**City of Sherwood
PLANNING COMMISSION
Sherwood City Hall
22560 SW Pine Street
Sherwood, OR 97140
September 7, 2010 – 7 PM**

TO: Planning Commission

Julia Hajduk, Planning Manager

Proposal: The applicant has requested a site plan and conditional use approval for a 12,000 square foot public plaza at the northeastern corner of Pine Street and Columbia Street. This is also the Final Development Plan for this portion of the approved Sherwood Cannery Square PUD (PUD 09-01). The applicant has also included a phasing plan for the remainder of the PUD with this Final Development Plan proposal. The applicant's submittal packet is attached as Exhibit A.

SCALE	DATE	05.21.10
	BY	005
SHEET	E5.1

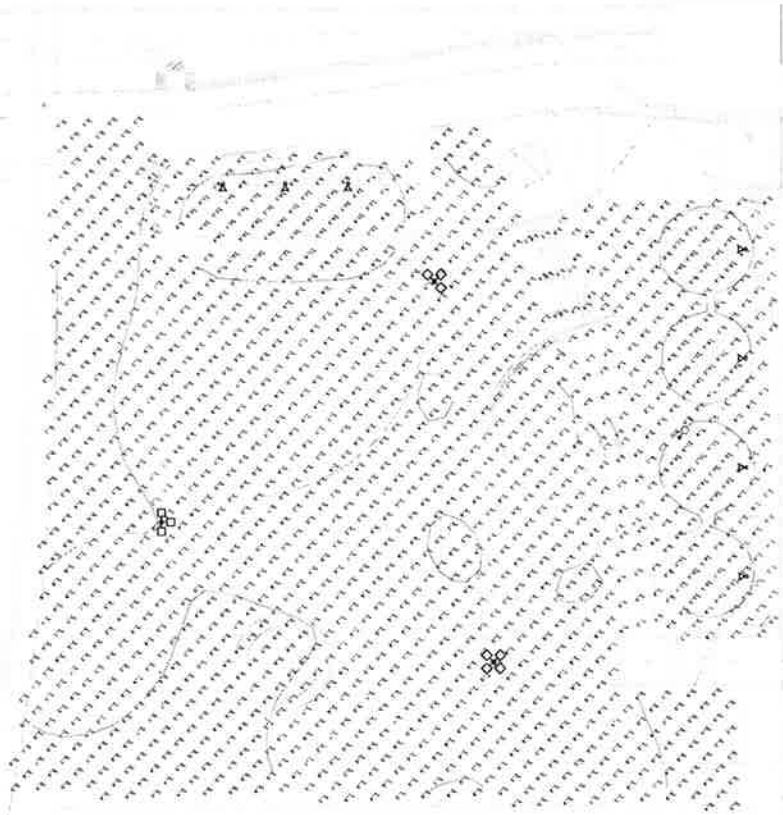
There are three pole mounted lights shown on the plans. The plans do not clearly indicate the height of the poles; however Sheet E5.1 demonstrates that the lighting will not exceed 0.5 foot candles beyond the property line. Staff is concerned that without more details on the height, style and type of lighting proposed, confirmation that the lighting is installed in accordance with the approved plans will be difficult.
